Environmental Impact Statement; Availability, etc.: Indian Point Nuclear Generating Unit Nos. 2 and 3, Buchanan, NY; License Renewal and Public Meeting

Entergy Nuclear Operations, Inc.; Indian Point Nuclear Generating Unit Nos. 2 and 3; Draft Supplemental Environmental Impact Statement; Request for Comment

NL-16-021

**Entergy Comments on Section 3.0 of the Draft Supplement
(Revised SAMA Engineering Project Cost Estimates)**

Figure 5. Percent of Hudson River Rainbow Smelt (*Osmerus mordax*) observed with *Glugea hertwigii* infestation present by River Run (week) during 1991.

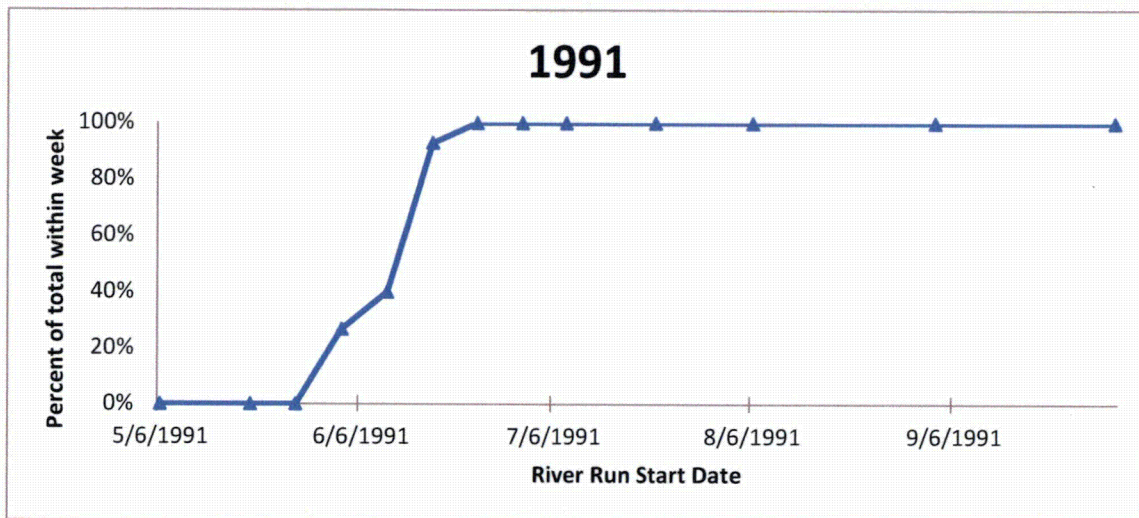
In both 1991 and 1993, a clear trend of increasing infestation over time (*i.e.*, over the course of the annual River Runs) and with increasing fish length was demonstrated.²⁷ As shown in Table 6 and Figure 5 of Appendix 2B, in 1991, fish from River Runs 4 through 8 (May) were predominantly free from infestation until River Run 9 (early June), at which time a transition appears to have taken place, with approximately 60% of fish found to be infested. Subsequently, in River Runs 10 through 19 (from mid-June on), almost all Rainbow Smelt were infested with *Glugea*.²⁸ The transition in mid-June from absence to presence of *Glugea* occurred within the 26-35 mm length classes²⁹ which corresponds with the transition from the PYSL life stage to YOY in Hudson River Rainbow Smelt. A similar pattern of infestation was

Figure 2 Annual CMR (%) for river herring at IPEC from 1974-1997, and maximum daily flow at Federal Dam between May 1 and June 15 of each year. The three years with highest CMR highlighted in yellow, and 4 selected years with low CMR and various levels of flow highlighted in blue.

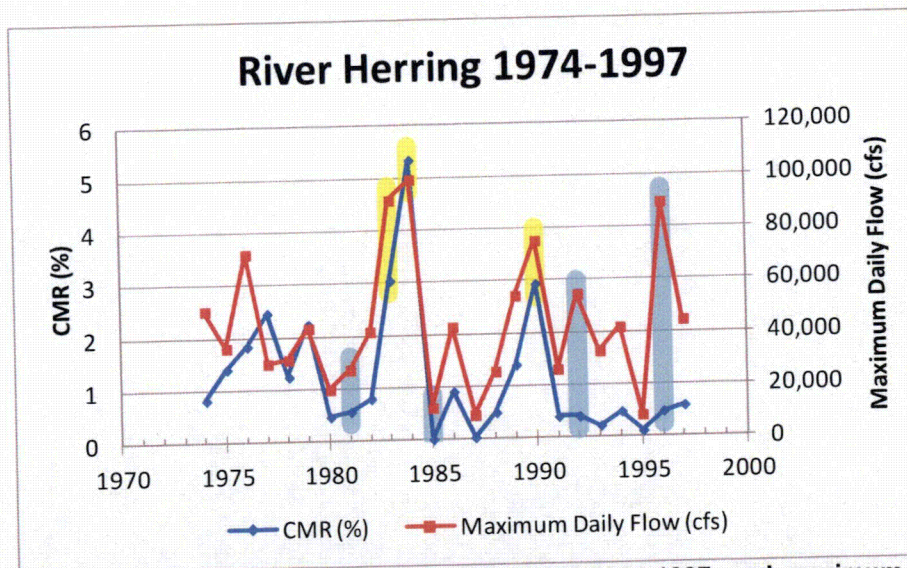
Examination of the CMR estimates from the DEIS, along with historical data on freshwater inflow to the estuary during the spawning season, indicates a strong relationship between the CMR and flow (Figure 2), which suggests the mechanism by which entrainment impacts at IPEC for this species are determined. Years with CMR of 3% or higher, e.g. 1983, 1984, 1990, experienced high freshwater inflow rates during the spawning and larval development period, May 1-June 15. Conversely, in years with low freshwater inflow rates, CMR was overwhelmingly below 1.5%, and often below 0.5%, e.g. 1985, 1987, and 1995. The spatial and temporal patterns of egg, larval,

Figure 9 Top – Relationship between maximum daily flow at the Federal Dam between May 1 and June 15 each year and river herring entrainment CMR at IPEC (1974-1997). Bottom – Cumulative frequency of maximum daily flow at the Federal Dam between May 1 and June 15 each year, (1947-2009)

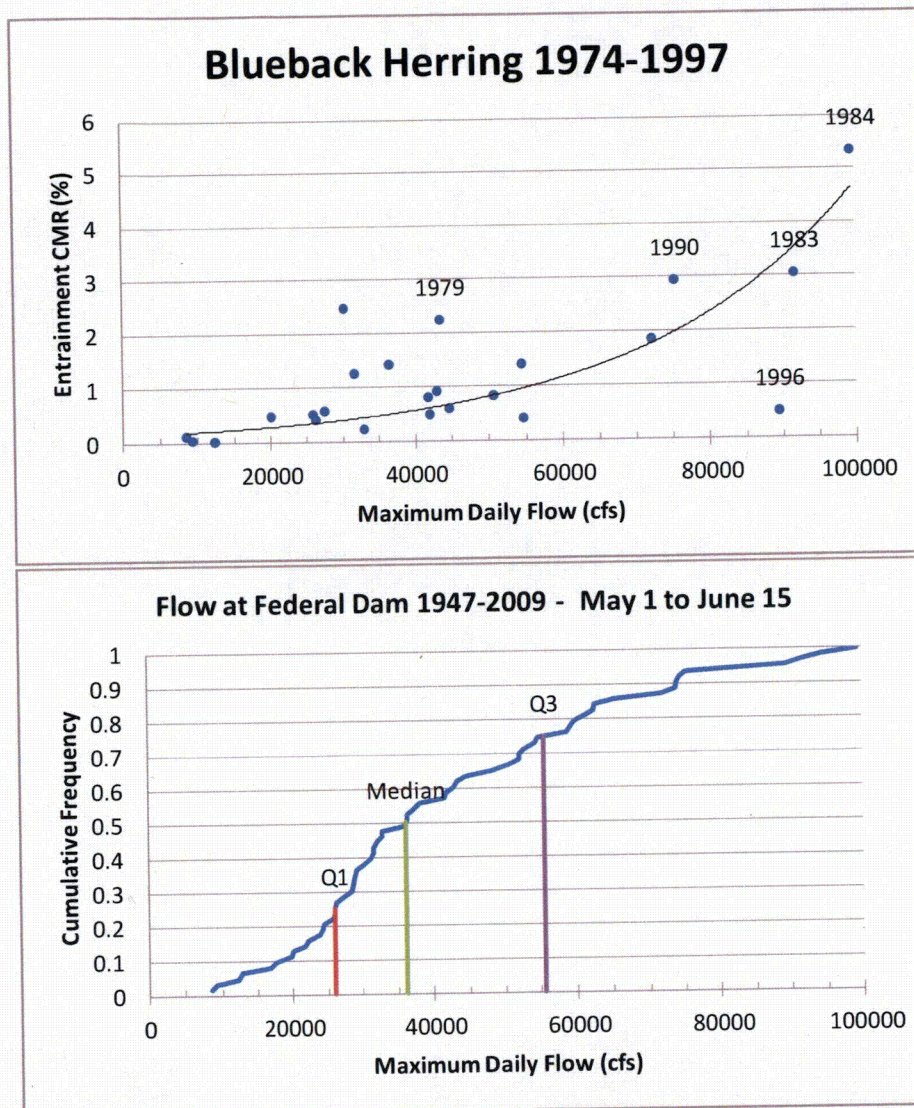
Hudson River Flow (in cfs) between May 1 and June 15 for the same span of years. As Figure 9 (top) shows, in 15 of the 24 years, the CMR value is below 1%. Indeed, the CMR estimate exceeds 3% in only two out of 24 years (1983 and 1984), and, in a third year (1990), the CMR approaches 3%. In all three of the years, the measured maximum daily flow exceeded 75,000 cfs, which corresponds to the 90th percentile of maximum flow measurements taken during this time period.⁵⁶ Thus, although high-flow events did not guarantee a high CMR estimate (as evidenced by the year 1996, in which a maximum flow of almost 90,000 cfs corresponded to a CMR of roughly 0.5%),⁵⁷ CMR values of roughly 3% or higher occurred *only* in infrequent years that had an unusually high flow events in the May 1 to June 15 timeframe.

Overall, the relationship of entrainment CMR with maximum daily flow demonstrates that entrainment mortality rate is strongly driven by extreme flow events, with the 3 years with highest entrainment CMR occurring during 3 of the 4 highest maximum flows (Figure 9). These high CMR values, although still generally less than $\frac{1}{2}$ of the EMR used by NRC, occurred when maximum daily flow exceeded about 75,000 cfs, approximately the 90th percentile of maximum daily flow.

Figure 4: Rainbow Smelt – Predicted Egg Entrainment Based on Riverwide Egg Abundance (Note: entrainment of eggs were only recorded in 1986 when entrainment sampling was conducted in March).

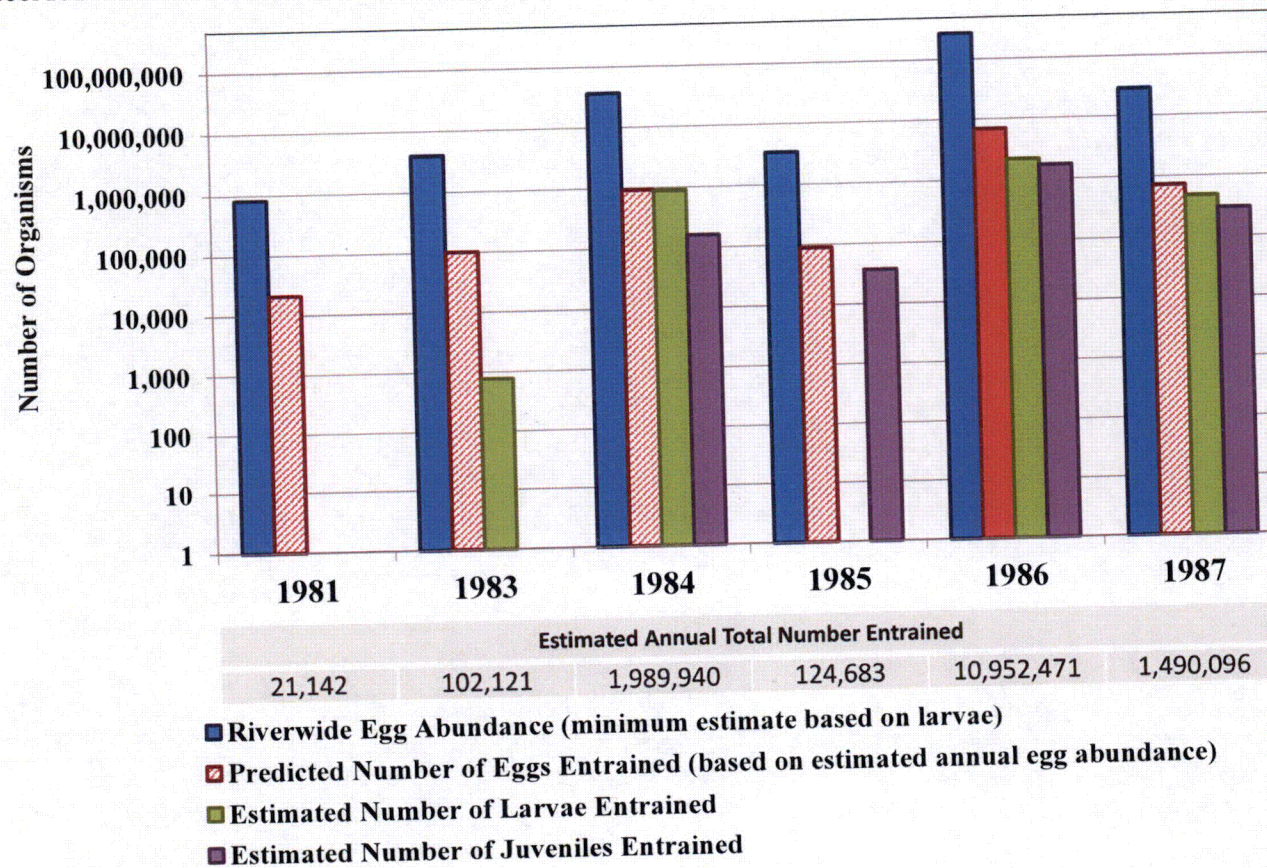
Figure 4 of Appendix 2D shows the predicted values of egg entrainment in these years (on a log10 scale) based on application of the ratio of egg entrainment to minimum River-wide egg abundance in 1986 to the estimate of minimum River-wide egg abundance in each year. The estimated total number of eggs, larvae and juveniles entrained is presented numerically beneath each year. In Figure 4, the differences between the 1986 egg entrainment data (solid red bar) used by the NRC Staff and the year-specific predictions of egg entrainment (diagonal red-hashed bars) are readily apparent. These differences confirm that using the 1986 egg entrainment data for all six years is not a valid approach.

Figure 5: Rainbow Smelt – NRC Staff's Predicted Egg Entrainment (Note: entrainment of eggs was only recorded in 1986 when entrainment sampling was conducted in March)

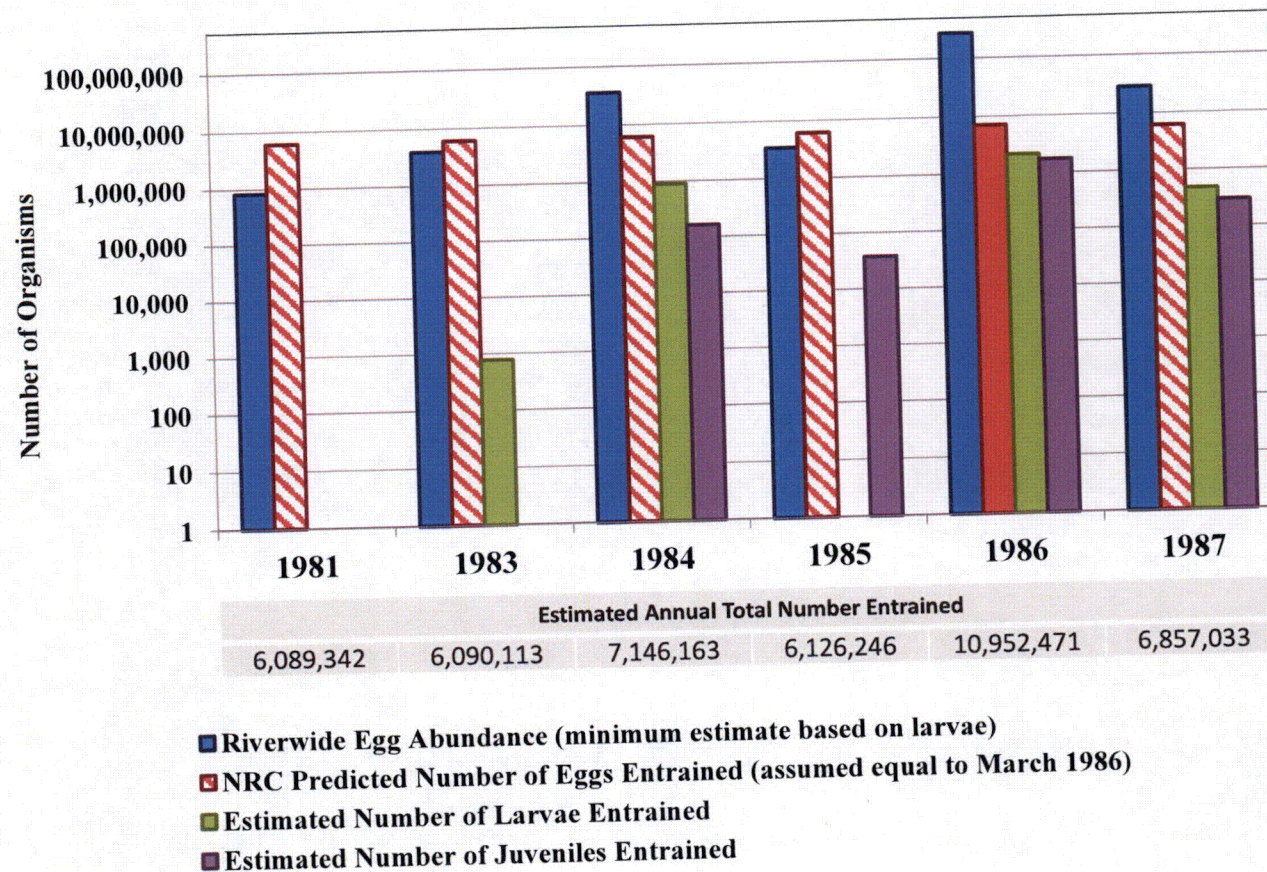
6. To calculate EMR for Rainbow Smelt, NRC Staff assumed the number of Rainbow Smelt eggs entrained in 1981, 1983, 1984, 1985 and 1987 was the same as the number entrained in 1986 (Figure 5).
